Memorandum

To	Genevieve Seed	Page	6
CC	Garry Bailey		
Subject	Rix's Creek Continuation Project, Revised Response to Submissions - Additional Questions from the Department of Planning and Environment		
From	Simon Murphy		
File/Ref No.	60289290	Date	21-Feb-2018

FIGURE 1

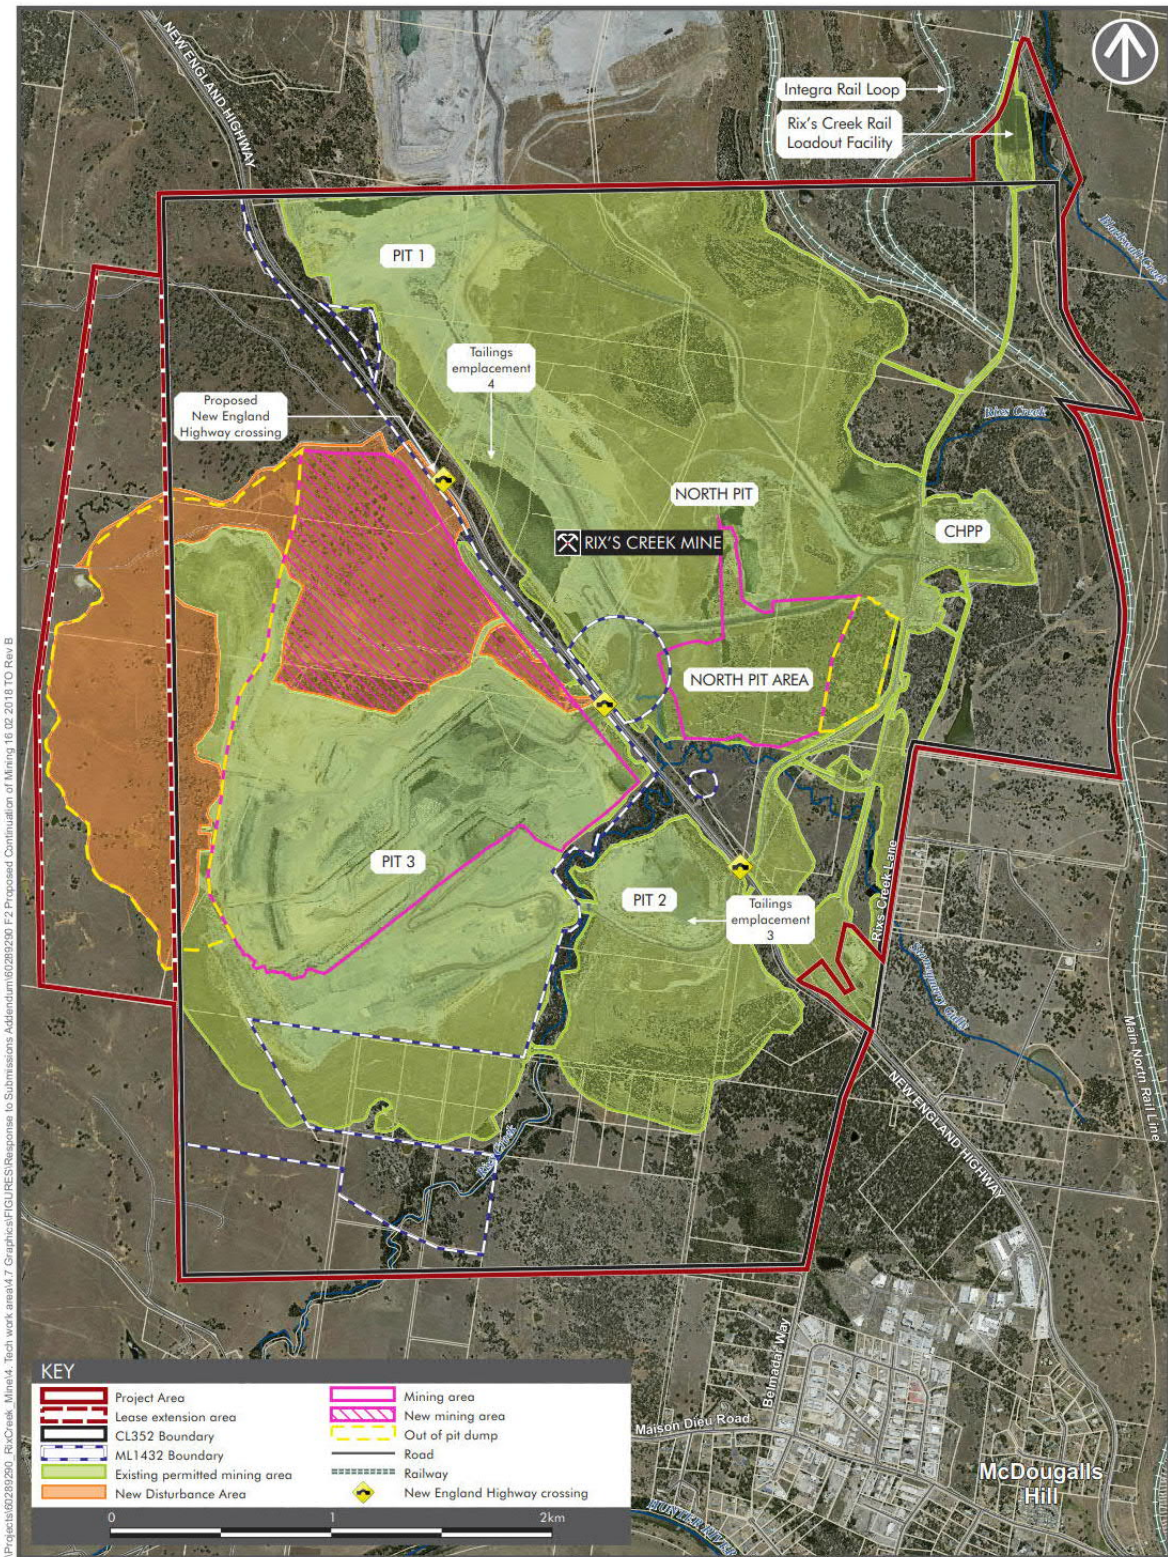
- Please provide an updated approved project layout, similar to Figure 1-3 of the EIS with the following changes:
 - Show only the approved DA 49/94 boundary ie remove the lease extension area to the west and the extension area to the northeast over the Integra rail loadout facility;
 - Label the Integra rail loop and loadout facility;
 - Show the approved internal haul road to Rix's Creek North; and
 - Show the approved disturbance areas (ie green area in court order).

Please see a copy of the requested figure attached to this memo as **Figure 1**.
